# Garland LE- ADA Evaluation

**LE- Garland TX, ADA Evaluation**  
**346 Oaks Trail Suite 100**  
**Garland, TX 75043**  
**Accessibility Evaluation**  
**Inspection Date: 03/23/2023**  
**Inspectors: Christopher Meza**

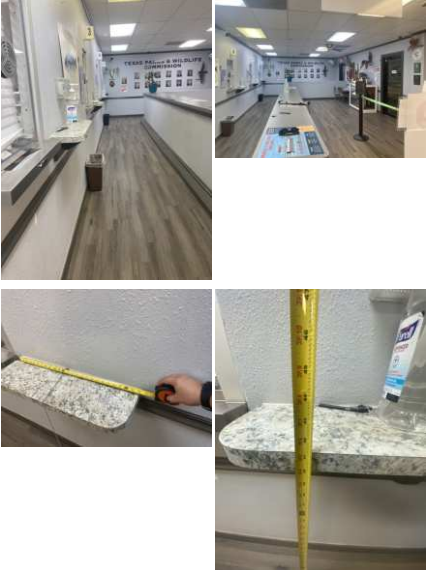
11	Exterior of Property (Public): Path of Travel to Building - Curb Ramp (Main Route)	The curb ramp on the accessible route has cross slopes greater than 2%. Surface cross slopes shall not exceed one unit vertical in 48 units horizontal (2-percent slope).	Curb ramp cross slopes exceeds 2% in 2 locations. Cross slope on (L) side of curb ramp is 11.2%. Cross slope on (R) side of curb ramp is 5.1% Curb ramp running slope meets requirements.		<a href="https://www.access-board.gov/ada/#ada-405_3">https://www.access-board.gov/ada/#ada-405_3</a>  2012 TAS Section: 405.3, 406.1  2010 ADAS Section: 405.3, 406.1
